AIR - PROVIDE REVISED MATERIAL TUBE CLIP AT CLIPPING POINT LOCATION CP5776 - CATEGORY
CODE 4 - MOD.ENG-75-0004

V2500-ENG-75-0004

Replacement of the clip at clipping point CP5776
Fig.1

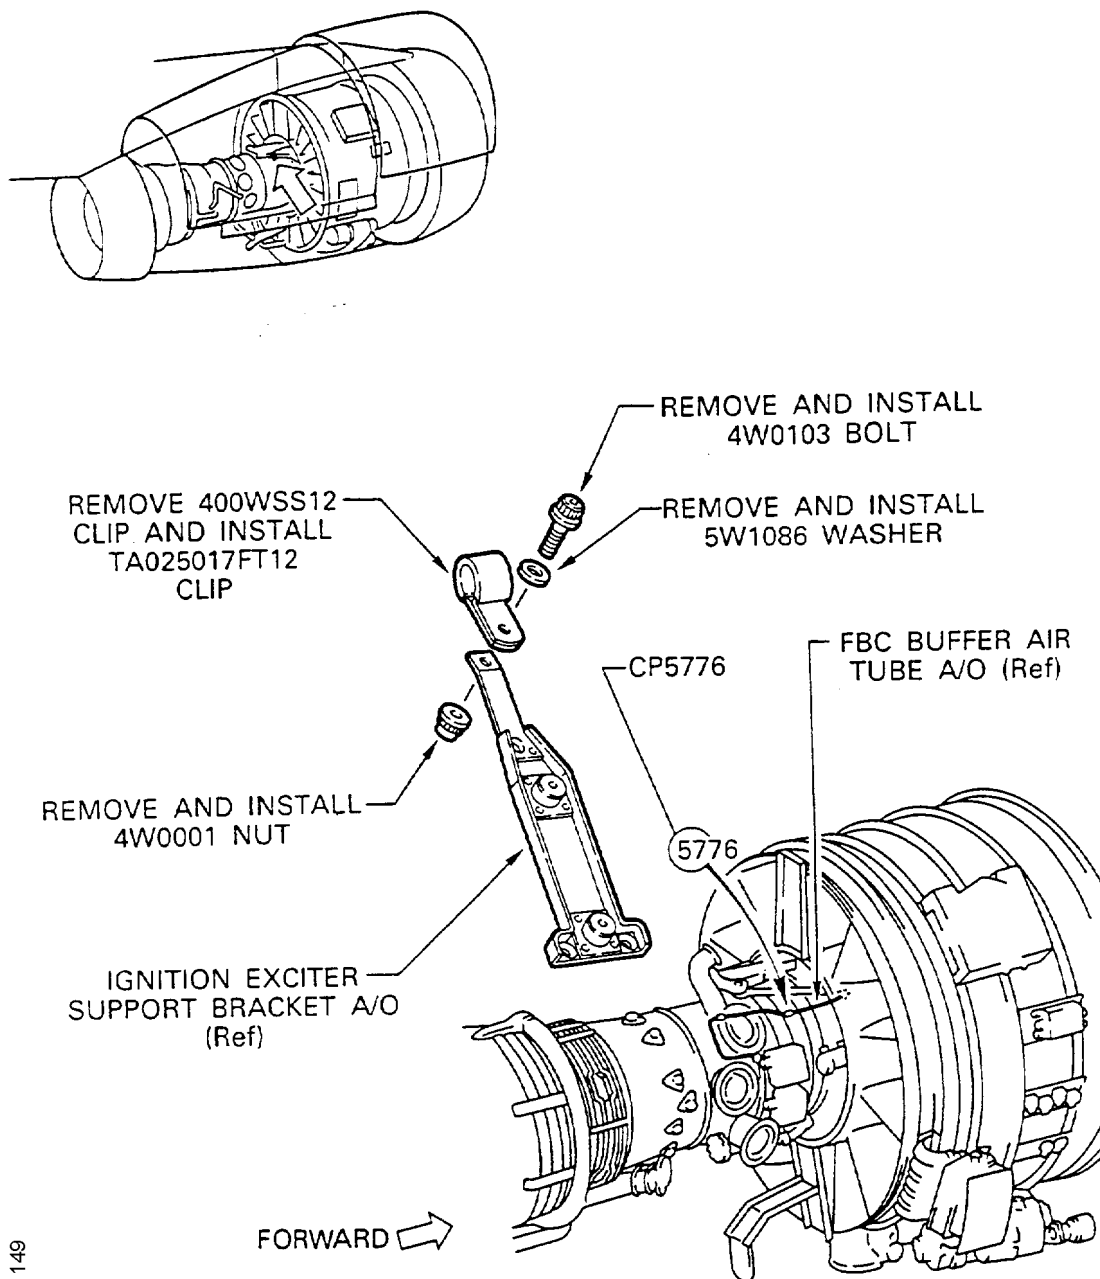
The existing rubber cushion clip attached to the Bearing Compartment Cooling and Sealing Tube at CP5776, could be affected by the high temperatures in the Core Engine Zone.

This could result in ineffective clipping for the Tube.

A review of the clip at CP5776 has shown that the glass-wool cushion clip will increase durability over the existing clip.

(a) The clip at CP5776 has been changed from the Adel clip to the TA-clip to increase the durability. (see Figure 1.)

- (1) Find clipping point CP5776 which safeties the FBC Buffer Air Tube A/O. (Refer to Figure 1.)
- (2) At CP5776, remove PN 4W0001, Nut, PN 4W0103, Bolt, PN 5W1086, Washer and PN 400WSS12, Clip from the FBC Buffer Air Tube A/O and the Ignition Exciter Support Bracket A/O. (Refer to Figure 1.)
- (3) At CP5776, Install new PN TA025017FT12, Clip, PN 5W1086, Washer, PN 4W0103, Bolt and PN 4W0001, Nut to the FBC Buffer Air Tube A/O and the Ignition Exciter Support Bracket A/O. (Refer to Figure 1.)
- (4) At CP5776, Torque the Nut to 36 – 40 lbfin (4,07 – 4,52 Nm). (Refer to The Aircraft Maintenance Manual, 70-23-11, Torque Tightening Technique.)
